Addendum No. 2 to IFB 18-24

To: All Parties on Record with the City of Somerville as Holding IFB 18-24, **Somerville Avenue Utility and Streetscape Improvements**

Re: Extend Bid Submission Deadline, Answer Questions during Q/A Period, Clarify Qualifications Requirements, Revise Unit Price Form, Revise Technical Specifications, Append List of Bid Holders

Addendum No. 2

Attachment 10 – Sketch SK-SD-77-1

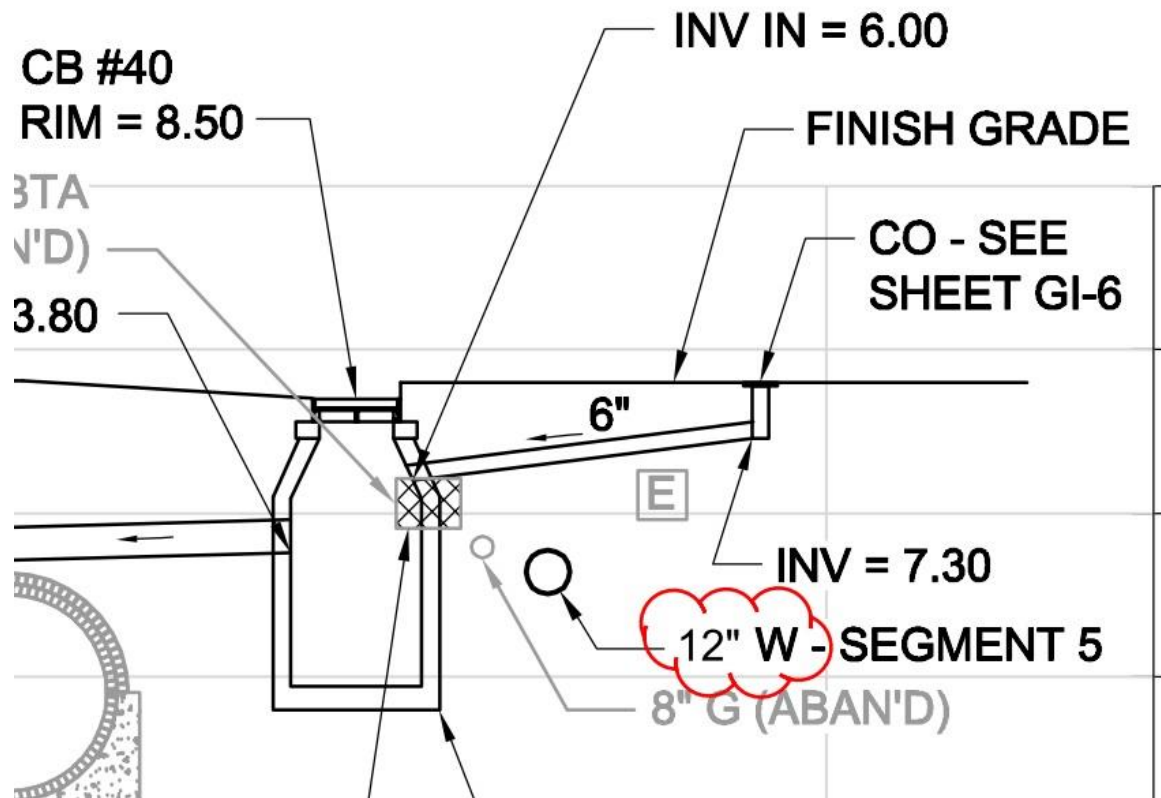
30. **Drawings – Sheet SD-67**
ADD information on CB#42 and RISER#35 to the table, as indicated in SK-SD-67-1, included as Attachment 9 to this Addendum No. 2.
31. **Drawings – Sheet SD-77**
In Section 40, **REVISE** the callout for the Segment 5 water main to 12”, as indicated in SK-SD-77-1, included as Attachment 10 to this Addendum No. 2.
32. **Drawings – Sheet L-100**
DELETE the callout “2” BIT. CONC. SURFACE COURSE (ITEM NO. 460-001)” and **REPLACE** with the following:
